To: INCITS Technical Committee T10
From: Kevin Butt
Date: Wednesday, April 08, 2009 7:49 pm
Document: T10/08-391r1 — SSC-3: Resolution to LB IBM-L2

This proposal intends to resolve LB IBM-L2:

[4.2.21.11, p2] Add a new sentence after s1:

Encryption Parameters in a device server

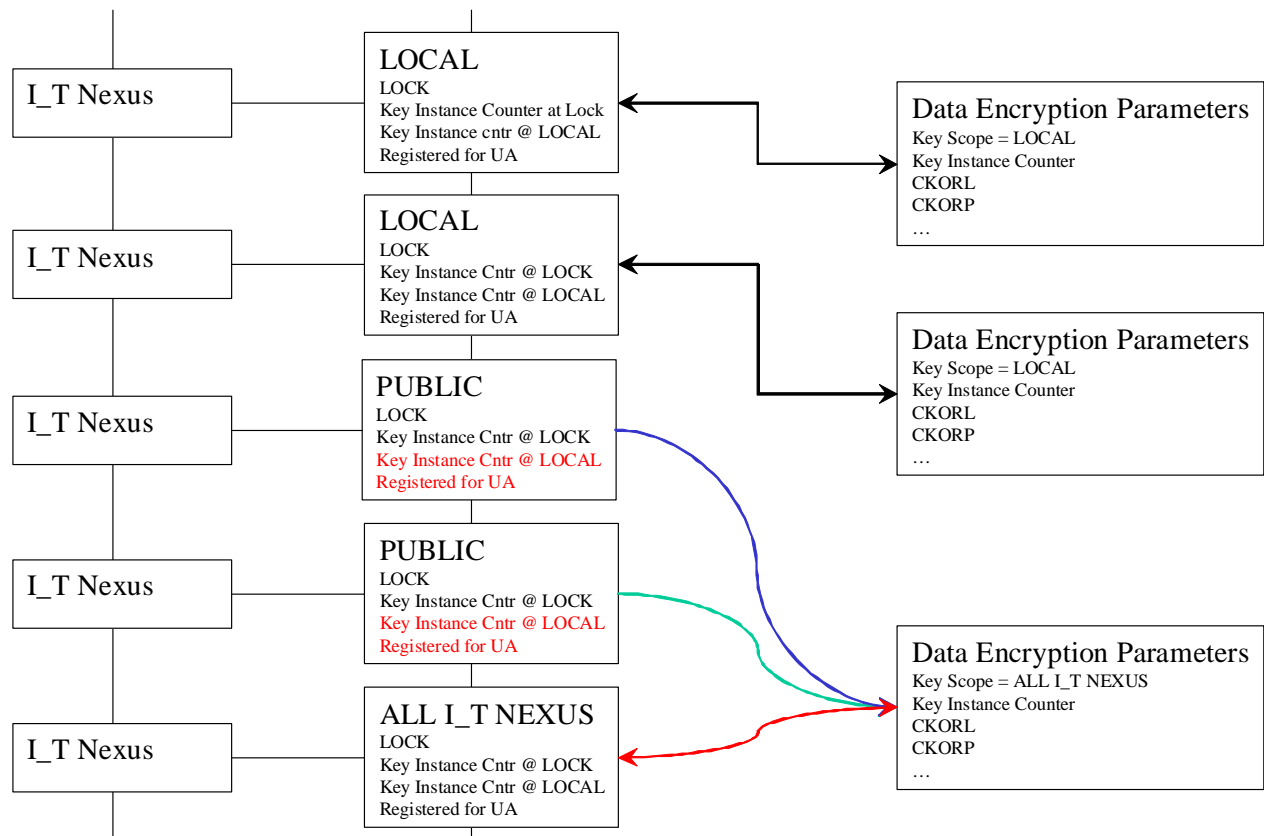
The following figure may help discuss the LOCK bit and what is required for it to function properly. Note that the red text in the figure are parameters that are not present in the specific case.
